MCPB
Item #13
6/10/04

MEMORANDUM

REVIEW TYPE: Preliminary Plan and Site Plan Review
APPLYING FOR: 34 One-Family Homes
PROJECT NAME: Potomac's Edge
CASE #: 1-04046 8-04018
REVIEW BASIS: Subdivision Regulations, Chapter 50, including:

ZONE: R-200/TDR-3
LOCATION: Westside of Travilah Road, at Lake Winds Way, approximately 1.25 miles south of Darnestown Road intersection

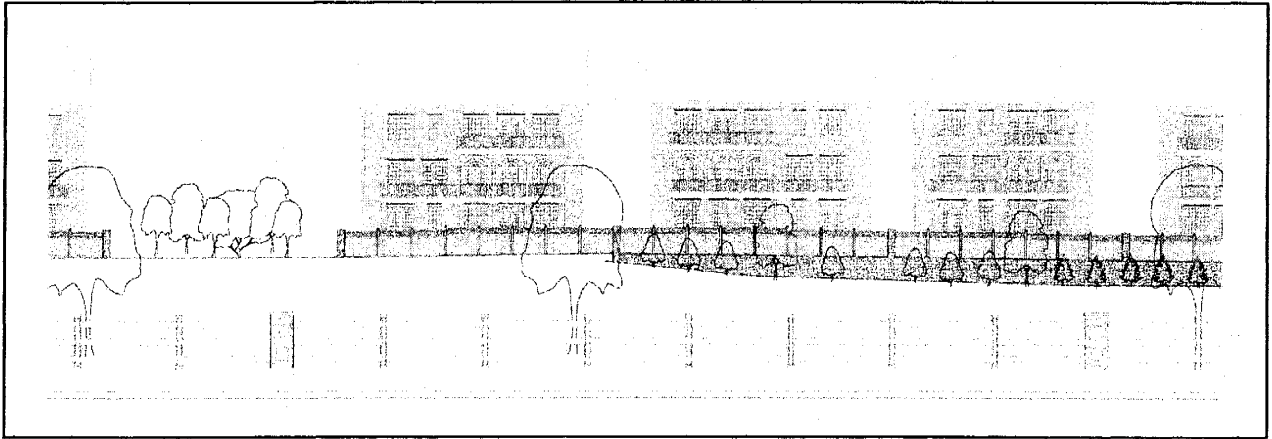
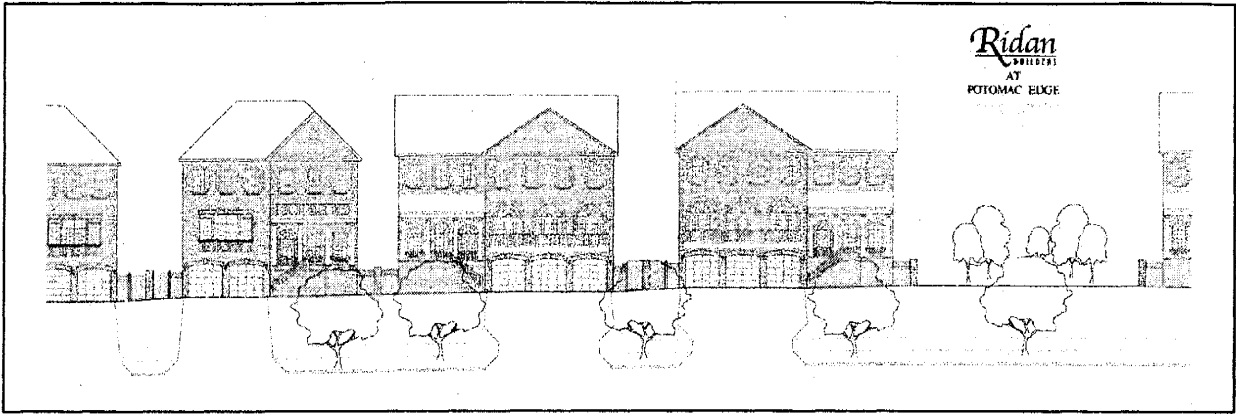
Potomac Edge plan showing the 75-foot wide Utility (Gas) Easement to the south, the vehicular and pedestrian entrance from Travilah Road. Note the underground stormwater management facility outlined in blue. The dark green areas designate the forest conservation easements. There are three open space areas that provide landscaping and sitting areas for visual interest and recreation. The pedestrian system (sidewalks) internal to the site are depicted by the yellow lines. Recreation provided meets the Recreation Guidelines. Staff has included a condition for the provision of sidewalks, street trees, and a bus shelter/bench for Travilah Road.
